SUNDRY NOTICES AND REPORTS ON WELLS
Do not use this form for proposals to drill or to re-enter an abandoned well. Use form 3160-3 (APD) for such proposals.

1. Type of Well <input checked="" type="checkbox"/> Oil Well <input type="checkbox"/> Gas Well <input type="checkbox"/> Other		5. Lease Serial No. NMLC062300
2. Name of Operator CHEVRON USA INCORPORATED		6. If Indian, Allottee or Tribe Name
3a. Address 6301 DEAUVILLE BLVD MIDLAND, TX 79706		7. If Unit or CA/Agreement, Name and/or No.
3b. Phone No. (include area code) Ph: 432-687-7375		8. Well Name and No. CO YETI 15 22 FED COM 0051H
4. Location of Well (Footage, Sec., T., R., M., or Survey Description) Sec 15 T25S R32E NWNE 10FNL 1335FEL 32.137733 N Lat, 103.658531 W Lon		9. API Well No. 30-025-45531-00-X1
		10. Field and Pool or Exploratory Area WC025G06S253206M-BONE SPRING
		11. County or Parish, State LEA COUNTY, NM

Revisions to Operator-Submitted EC Data for Sundry Notice #483350

**PECOS DISTRICT
DRILLING CONDITIONS OF APPROVAL**

BLOWOUT PREVENTER SCHEMATIC

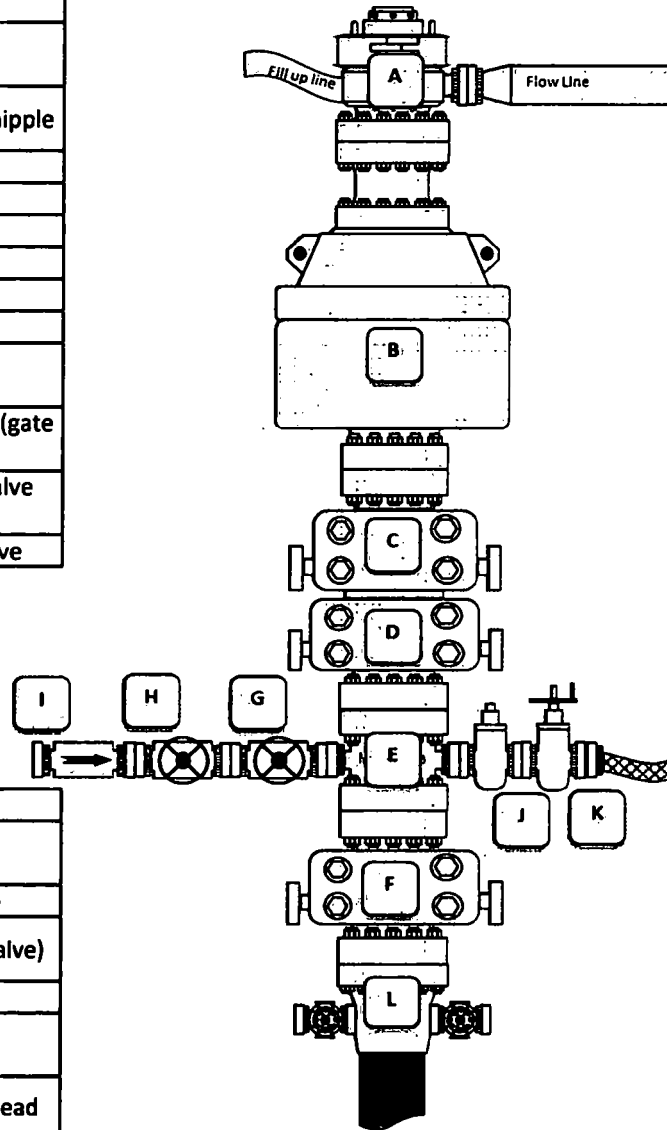
This sundry is to clarify the original COA's regarding pressure control equipment. The 5M BOP will be utilized on these wells after the surface shoe and throughout the entirety of the wellbore thereafter. The TVD for these wells are no deeper than 10,700' with pore pressures of 9.5 ppg. Therefore the MASP will NOT exceed 5M psi.

See attached BOP and choke manifold

- a. Minimum working pressure of the blowout preventer (BOP) and related equipment (BOPE) required for drilling below the surface casing shoe shall be **5000 (5M)** psi.
- b. Minimum working pressure of the blowout preventer (BOP) and related equipment (BOPE) required for drilling below the intermediate casing shoe shall be **10,000 (10M)** psi.
